Item Name: Replacement Skidtube

DRAWING NO. D2580	TITLE 205 SKIDTUBE ASSEMBLY	REV. E	DART AEROSPACE LTD ENGINEERING ORDER		D.E.O. NO. D2580-E-1	SHEET NO. SHEET 1 OF 1	SCALE NTS
DRAWN <i>UP</i>	CHECKED <i>ASS</i>	MFG. APPR. <i>ER</i>	APPROVED <i>##</i>		DE APPR. <i>##</i>		
DATE 11.12.13	DATE 11.12.13	DATE 11.12.13	DATE 11.12.13		DATE 11.12.13

CHANGE ALL C'BORED WELDED CROSSBOLT SPACERS TO SWAGED SPACERS

SECTION B-B, F-F, I-I
NOT TO SCALE

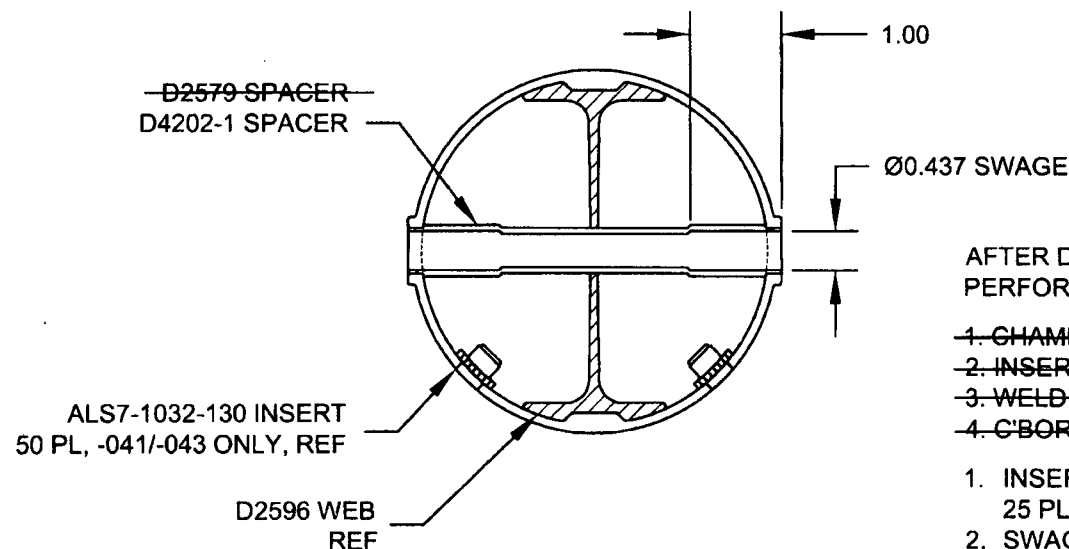
SECTION B-B, SECTION F-F, & SECTION I-I ARE AMENDED AS FOLLOWS
FOR ALL HOLES THAT WERE ORIGINALLY C'BORED:

*** FOR -045 SKIDTUBE ONLY:**
WELD 4X D2579 SPACERS PER DWG
IN LOCATIONS MARKED "NO C'BORE".
REF SHEET 4 OF DWG.

AFTER DRILLING AND BENDING ASSEMBLY
PERFORM THE FOLLOWING FOR Ø0.508 HOLES ONLY:

- ~~1. CHAMFER HOLE 0.050 X 45°~~
- ~~2. INSERT D2579 SPACER (20 PLACES)~~
- ~~3. WELD INTO PLACE AND GRIND FLUSH~~
- ~~4. C'BORE D2579 SPACER TO Ø0.437 X 1.00 DEEP~~

1. INSERT D4202-1 SPACER, 20 PL (-041) OR 20 PL (-045) OR 25 PL (-047)
2. SWAGE TO Ø0.437 X 1.00 DEEP PER QSI 002
3. TRIM / GRIND FLUSH PER QSI 002
